TEKOLAND SUBDIVISION

Engineering Comments: FINAL PLAT COMMENTS (should be addressed prior to submitting the FINAL PLAT for acceptance and signature by the City Engineer):

APPLICATION NUMBER 6 DATE November 7, 2019

DETAIL SITE PLAN

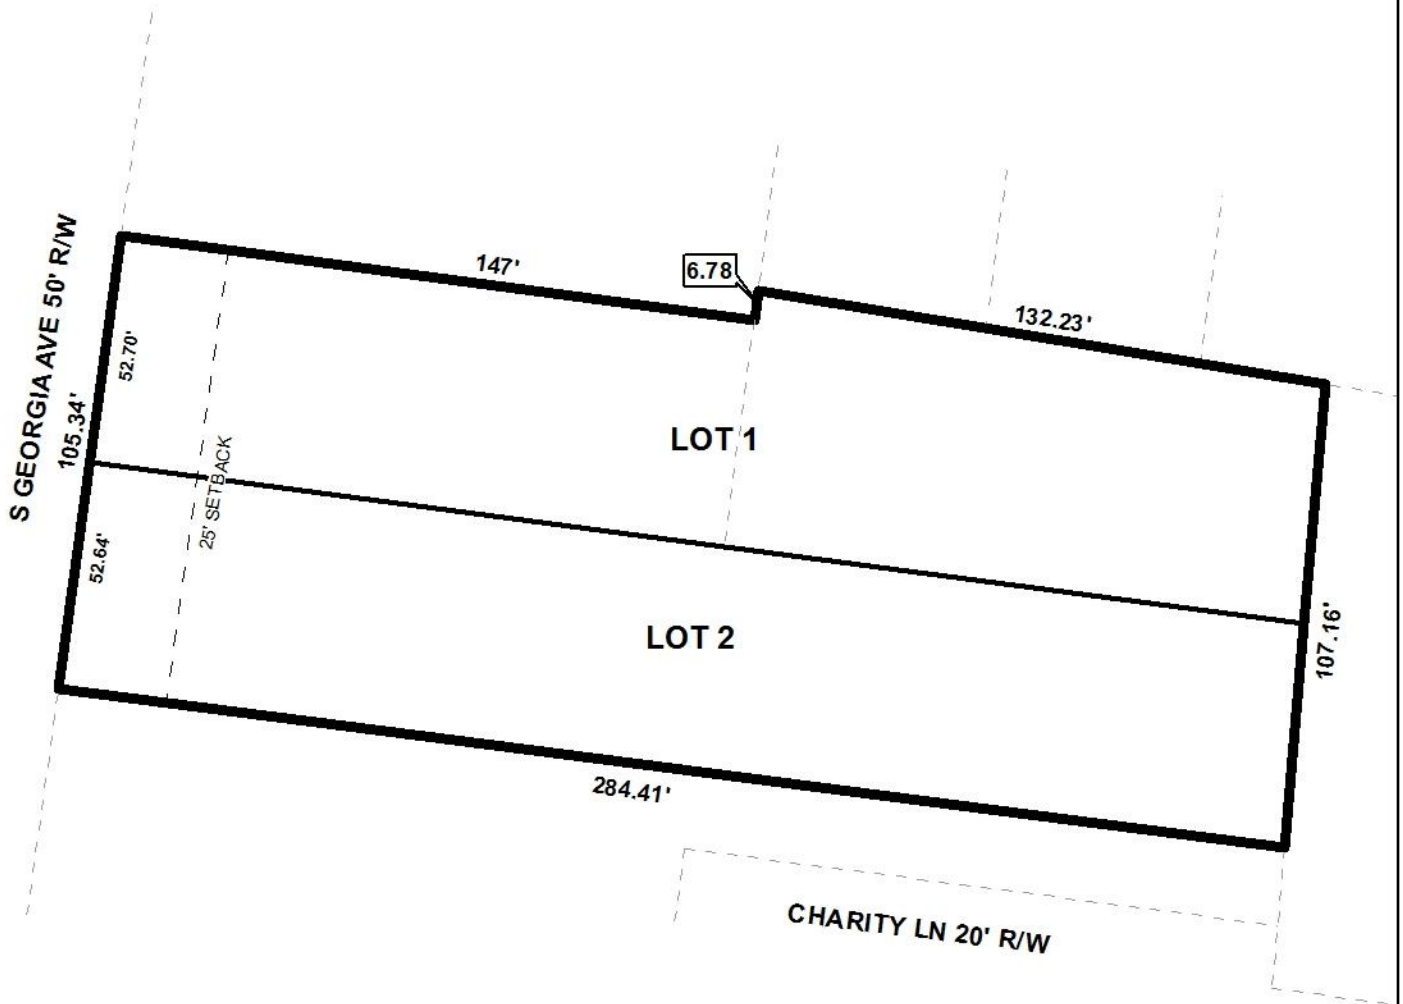
Both proposed lots front South Georgia Avenue, a minor street with compliant 50' right of way; therefore no dedication would be required. However, both Lots 1 and 2 as proposed will exceed the maximum width to depth ratio, thus, a waiver of Section V.D.3. of the Subdivision Regulations may be appropriate, as there are other similar lots in the area.

The subject property is located within a historic district, and therefore is granted relief from the normal building setbacks and site coverage limitation via the more flexible Historic District Overlay under Section 64-3.G. of the Zoning Ordinance. Therefore, it is recommended that Section V.D.9. of the Subdivision Regulations be waived, and that a note be placed on the Final Plat stating that all setbacks shall be determined by Section 64-3.G. Historic District Overlay requirements of the Zoning Ordinance.

The lot size labels in both square feet and acres should be retained on the Final Plat or a table should be furnished on the Final Plat providing the same information. As a means of access management, a note containing the Traffic Engineering comments should be placed on the Final Plat.

- 1) retention of the lot size labels in both square feet and acres on the Final Plat or the furnishing of a table on the Final Plat providing the same information;

- 2) revision of the Final Plat to remove the minimum setback line and provision of a note stating that all setbacks shall be determined by Section 64-3.G. Historic District Overlay requirements of the Zoning Ordinance;
